Re: 105 Forest Road & 1A Hill Street, Hurstville (SSD-84552728) – Traffic Response to RFI

Attachment 1

Response to RFI

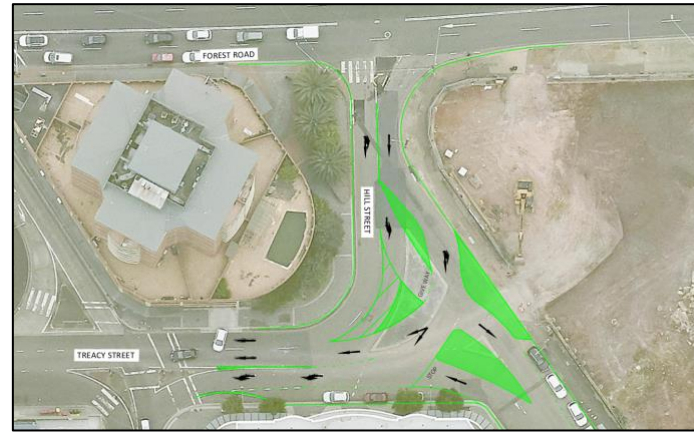
• Sightlines for Pedestrian Safety – there is no mention in the TIA, nor can it be reasonably determined from the architectural drawings,	A 3D perspective of the access driveway is provided below for reference, demonstrating compliant pedestrian sight lines.

if sightlines for pedestrian safety at the vehicle crossing satisfy the requirements of AS/NZS 2890.1:2004 Parking Facilities, Part 1 - off street car parking.
